MEMO

Subject: Comments on P. Saulsons's note on vibration isolation qualities of bellows

Date: July 22nd 1988

Fig. 1. Suggested impedance model

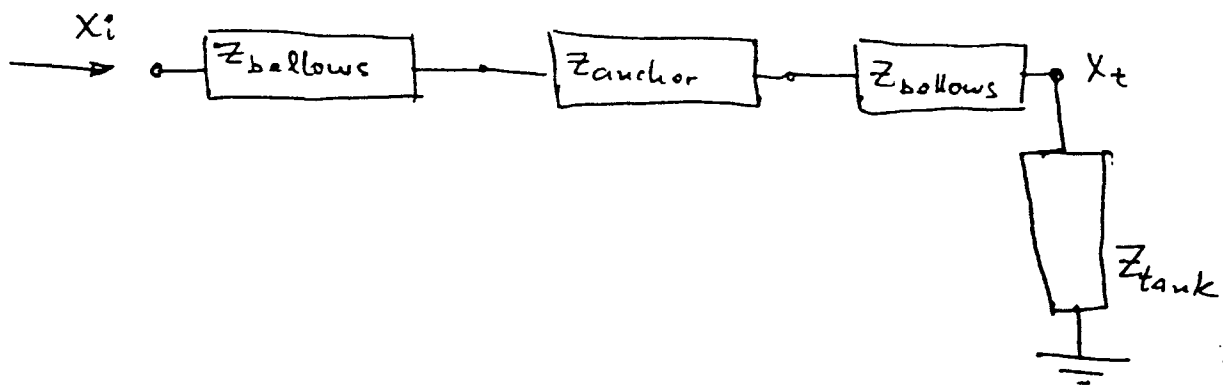
Consider the sequence *4 km pipe-bellows-short pipe-bellows-tank*, where the short pipe section is connected to the ground by a massive, rigid anchor (this is the case analyzed by Peter). Since anchors can be made extremely massive and rigid (e. g. a big, solid concrete block), the short pipe is likely to be the springier element in the pipe-anchor combination. The anchor acts only as an extension of the ground and bears on the transfer function only insofar as it influences the spring constant of the short pipe through the short pipe-anchor boundary conditions. It seems to me that the mass of the anchor thus becomes irrelevant.

The above argument then would suggest the impedance model shown in Fig. 1. I think this model is likely to display a substantially higher degree of vibration attenuation (at all frequencies) than the one used by Peter.
